ADDENDUM NO. 1

EASTERN OREGON UNIVERSITY

RFP #FP-2019-04N

EOU EMERGENCY BACKUP POWER SYSTEM – INLOW HALL

1 E0.10 ONE-LINE

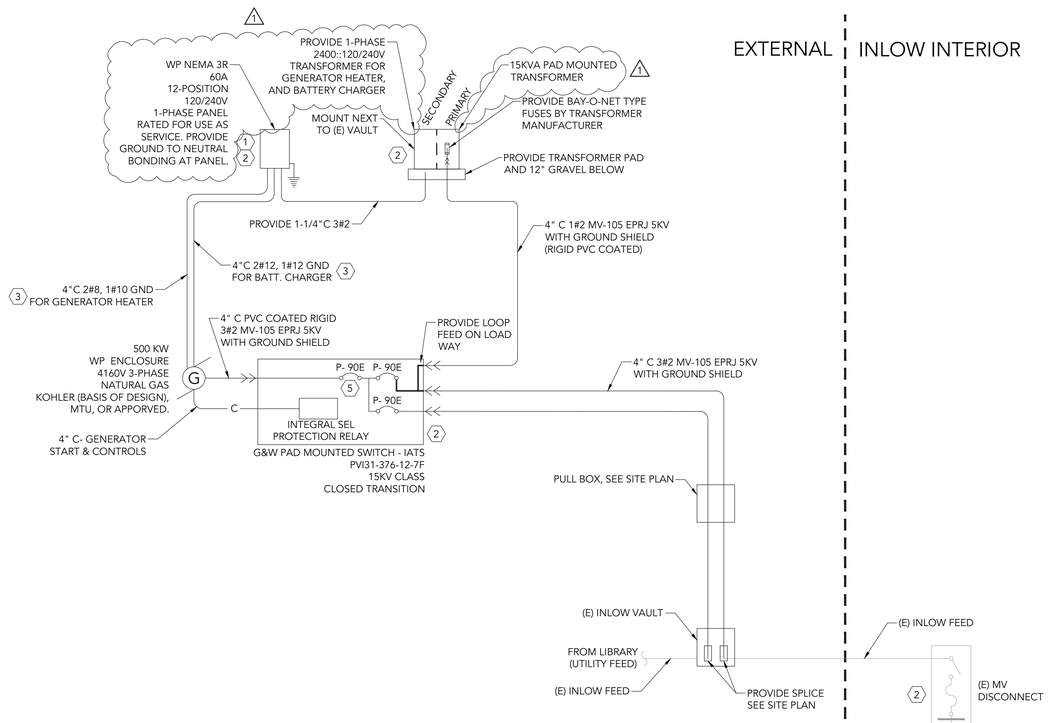
SHEET E0.10

Transformer at Generator shall be 15KVA. Transformer/Panel to be rated for 120/240V.

1 E1.00 DEMOLITION PLAN
SCALE 0 16' 32' 64'
1

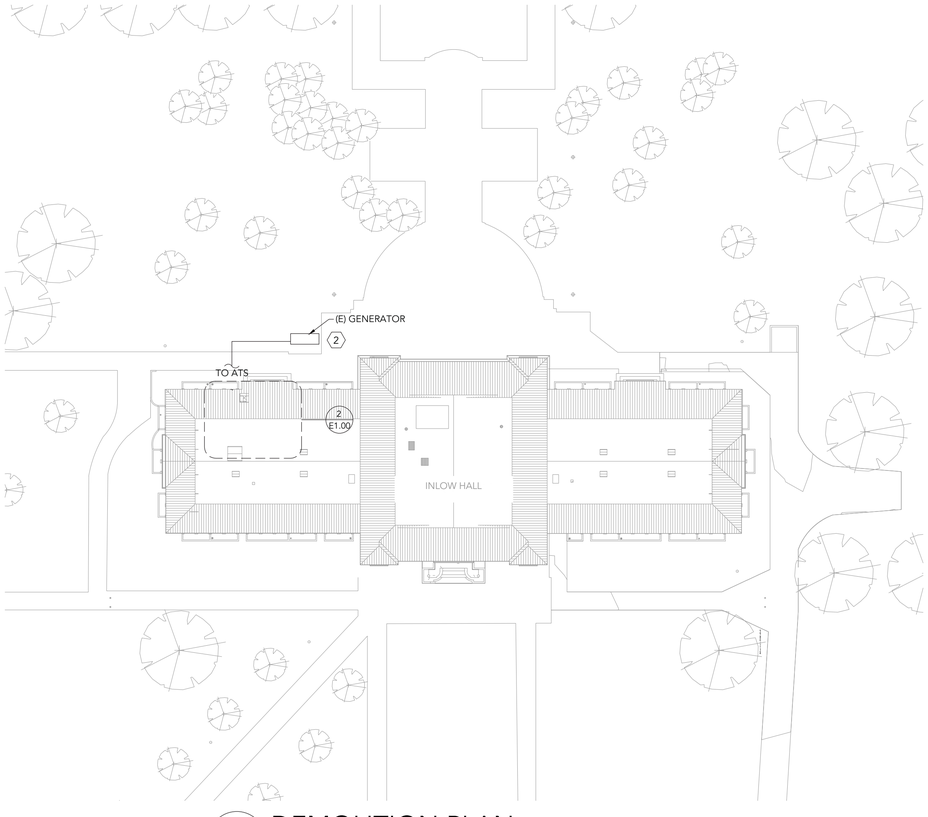
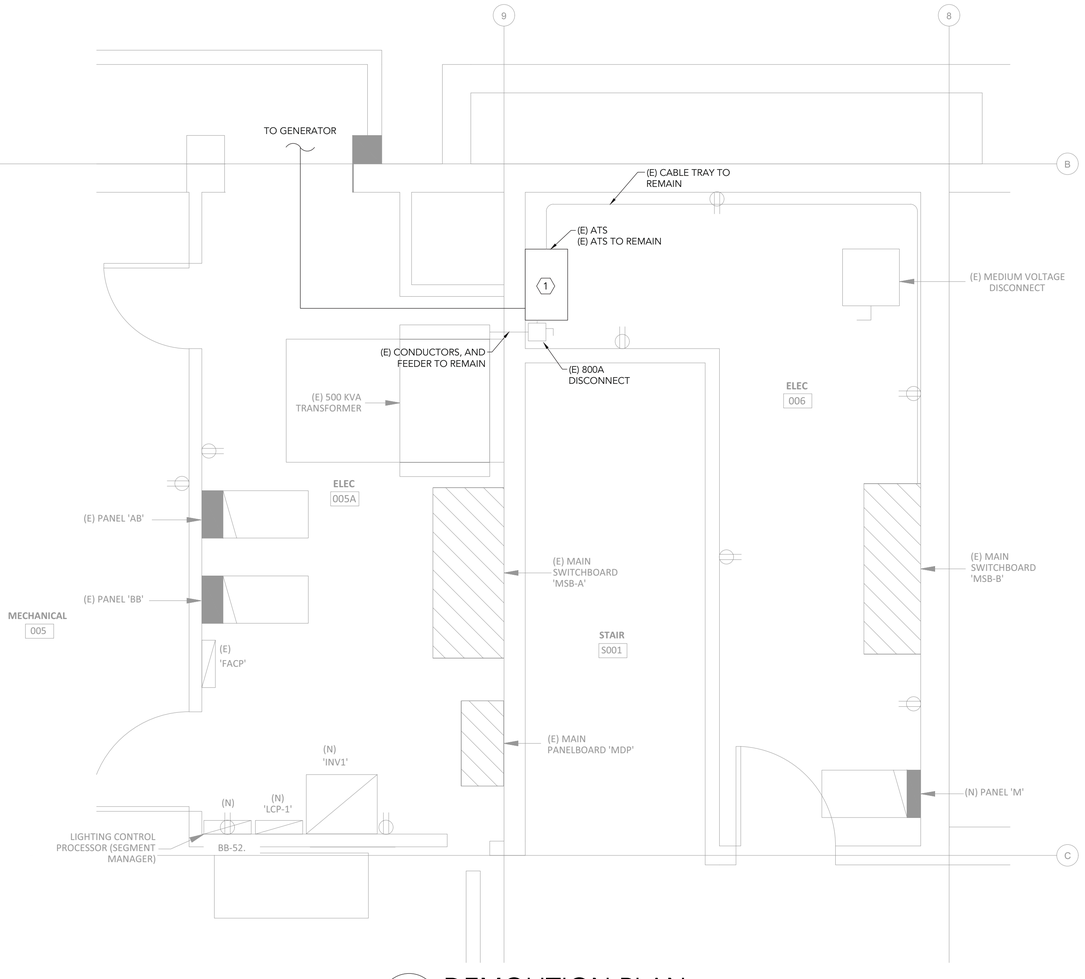
SHEET E1.00

Modifications to the scale for 'full size plans' :

1 E2.00 CAMPUS SITE PLAN

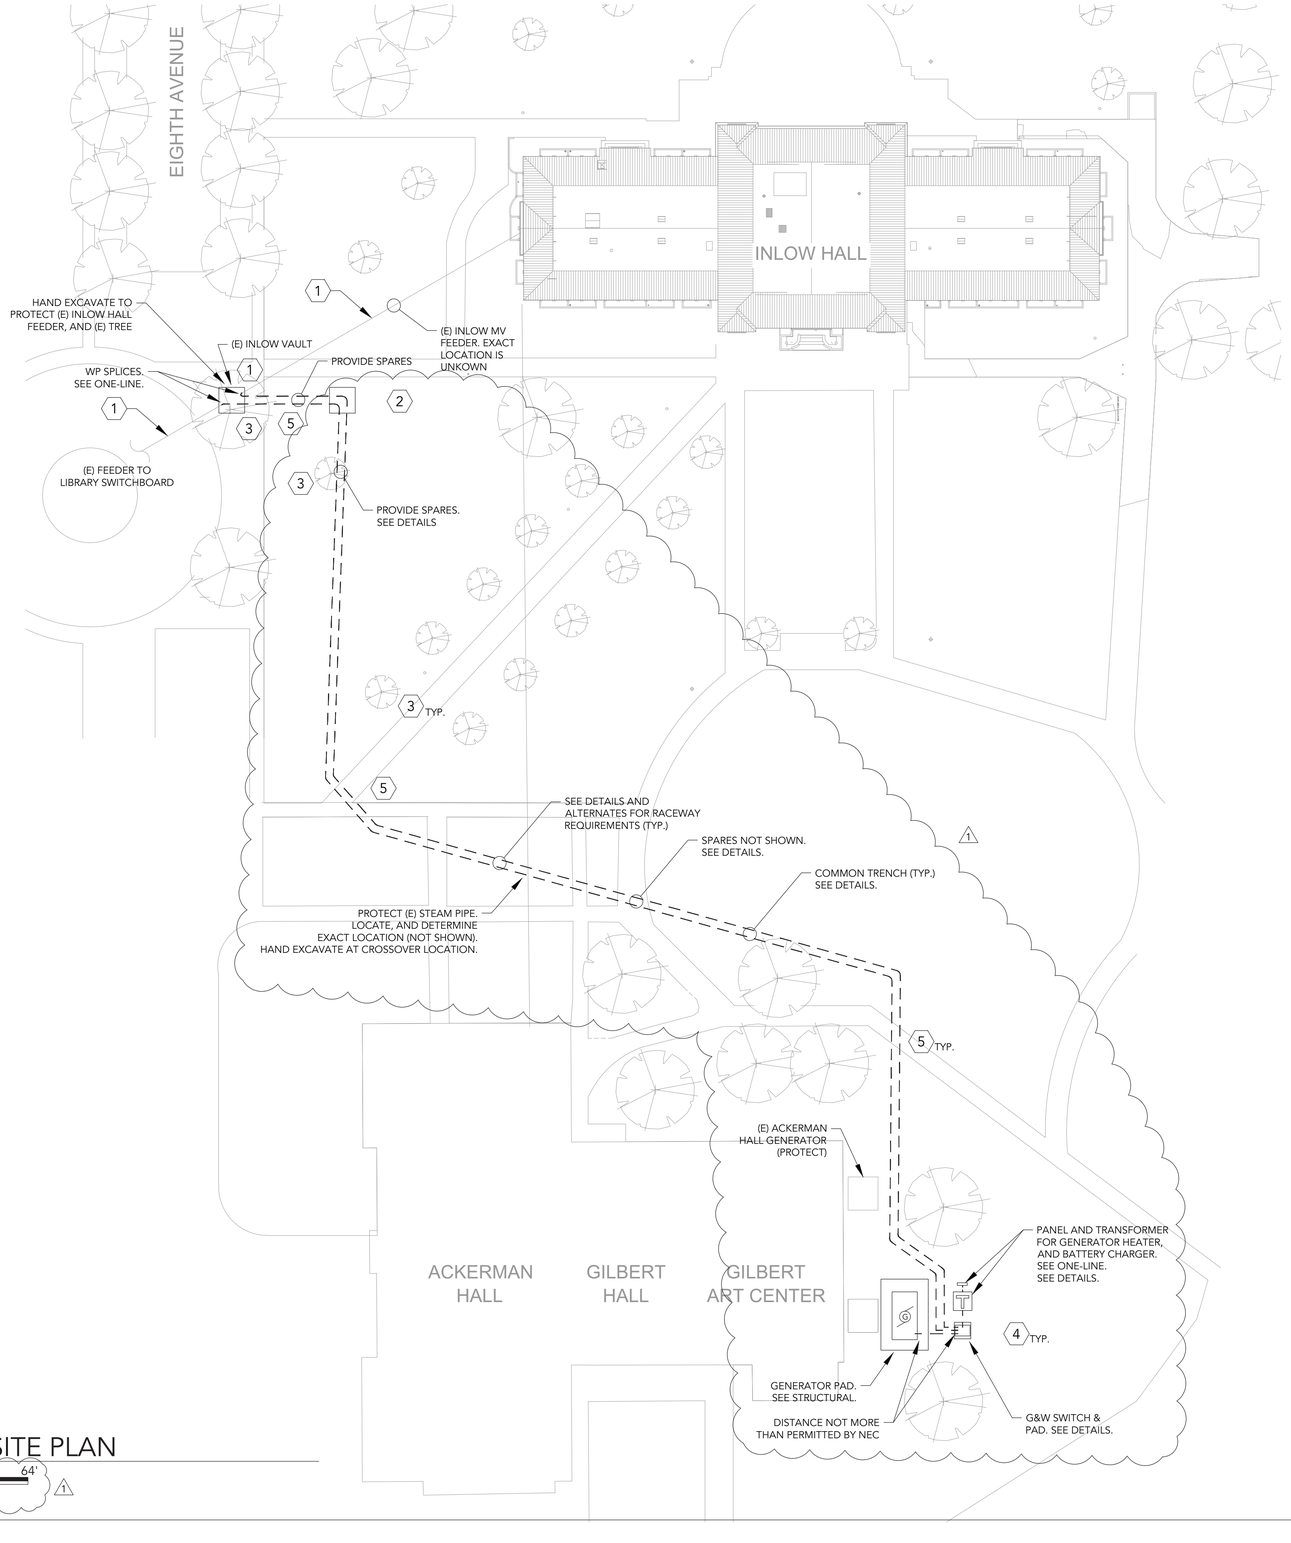
SHEET E2.00

Modifications to the scale for 'full size plans', modifications to the trench alignment to reduce impact to existing trees and reduce vertical grade breaks due to the required minimum and maximum trench depths.

1 E3.00 CONDUIT DUCT BANK - IATS TO PULLBOX

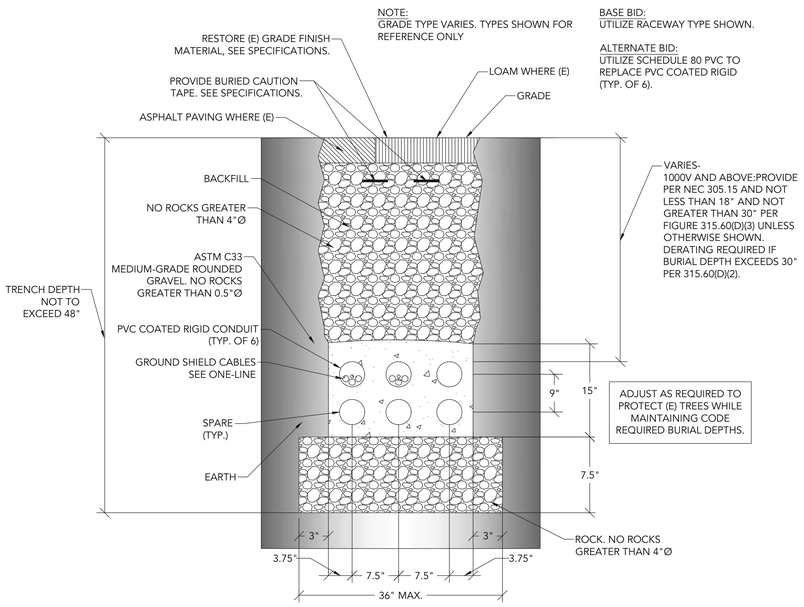
Q- Is a separate ground conductor required for the medium voltage feeders?

A: The cable is specified with a ground shield. The number of conductors shown in the trench detail (1/E3.00) is schematic/for referenced only; not intended to indicate number of conductors required. No additional ground (separate ground conductor) is required for the medium voltage feeds. A separate ground conductor (equipment grounding conductor) is required in the low voltage connections (120/208V).

3 E3.00 TRANSFORMER PAD (NOT BY EOR) ⚠1

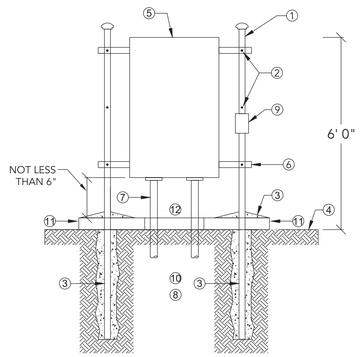
SHEET E3.00

Updated Transformer pad notation.
